ATTACHMENT 2

PROPOSED TECHNICAL SPECIFICATION CHANGES
FOR DRESDEN 3

FIGURE 2.1-3
(SCHEMATIC)APRM FLOW BEAS SCRAM RELATIONSHIP
TO NORMAL OPERATING CONDITIONS

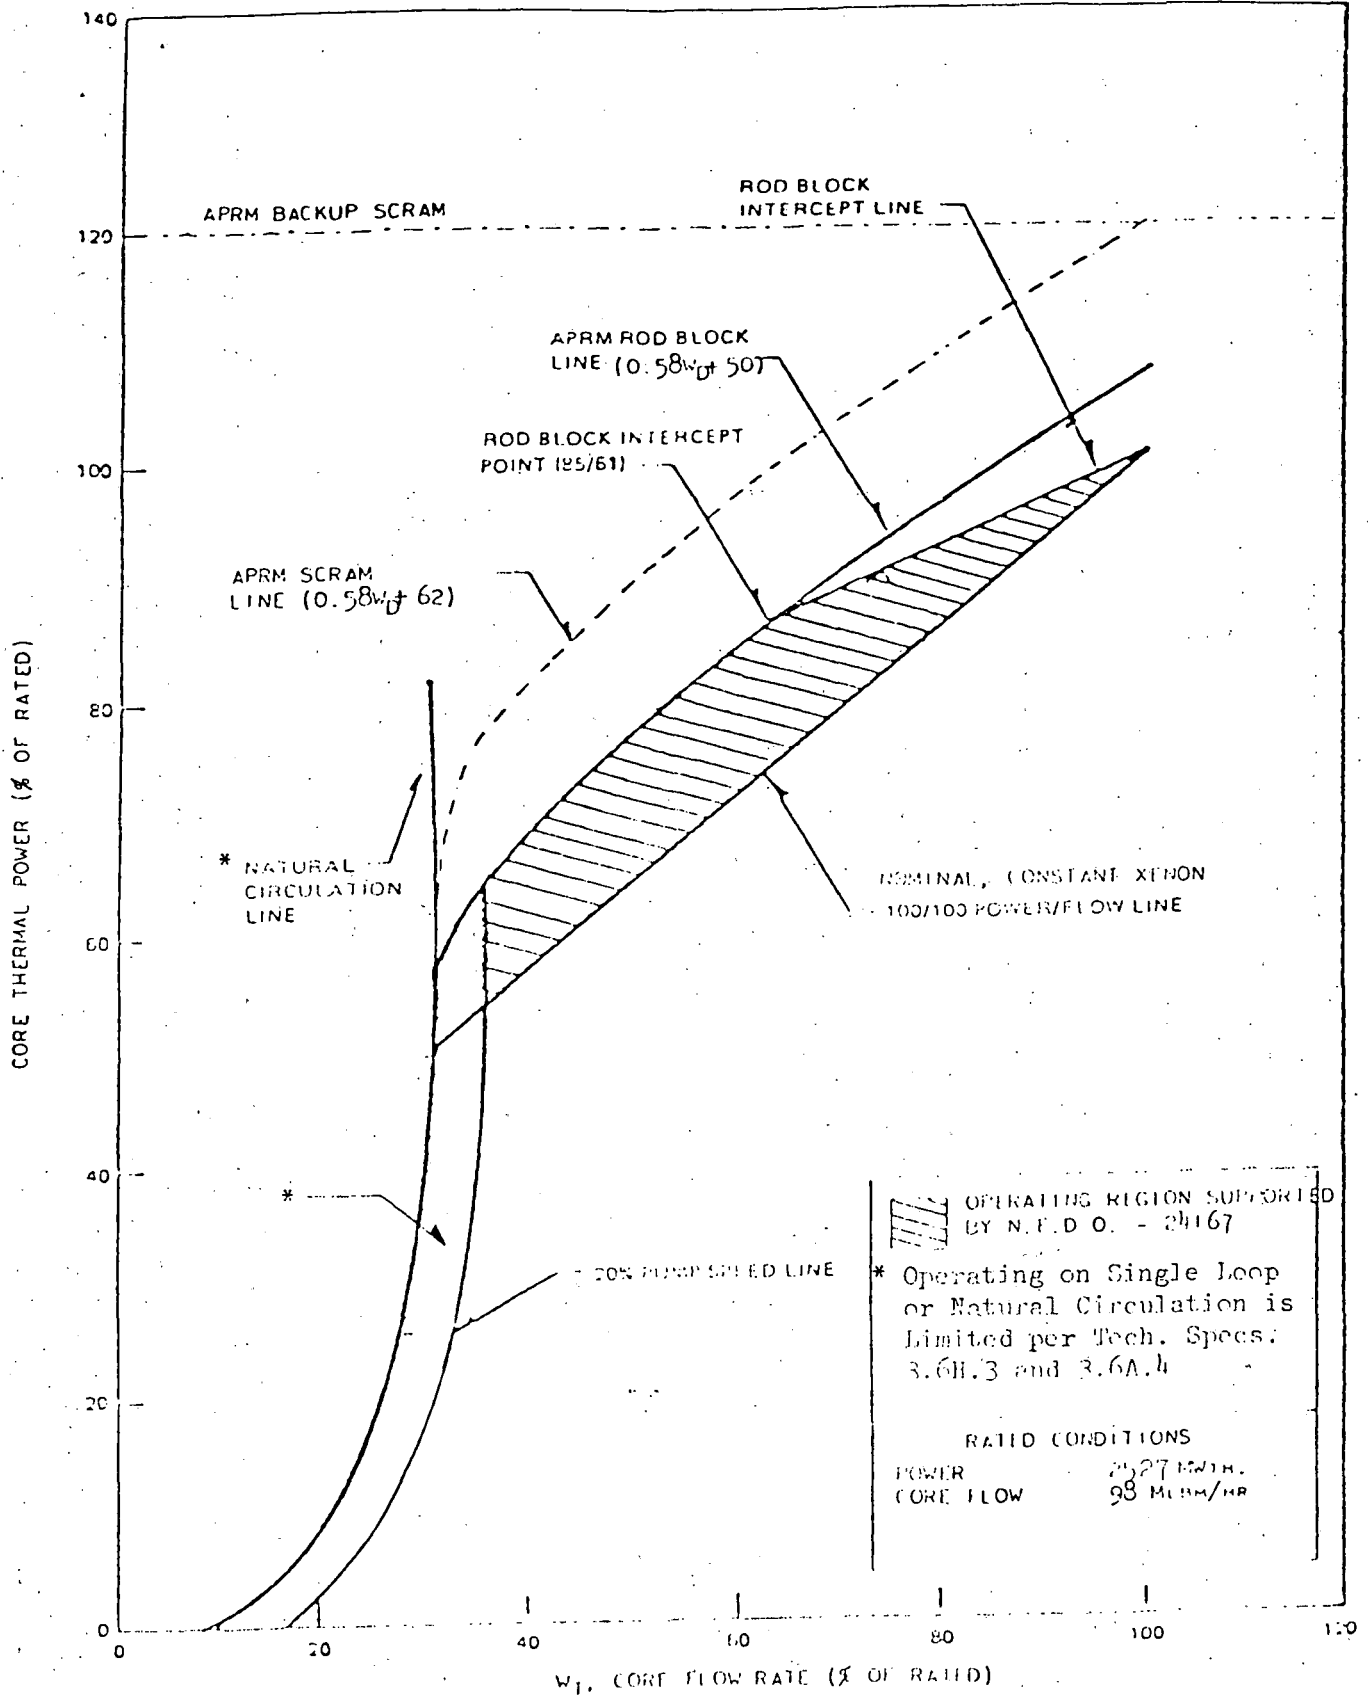
The APRM rod block setting shall be:

$$S \leq \left[0.58W_D + 50 \right] \left[\frac{LTPF}{TPF} \right]$$

The definitions used above for the APRM scram trip apply.
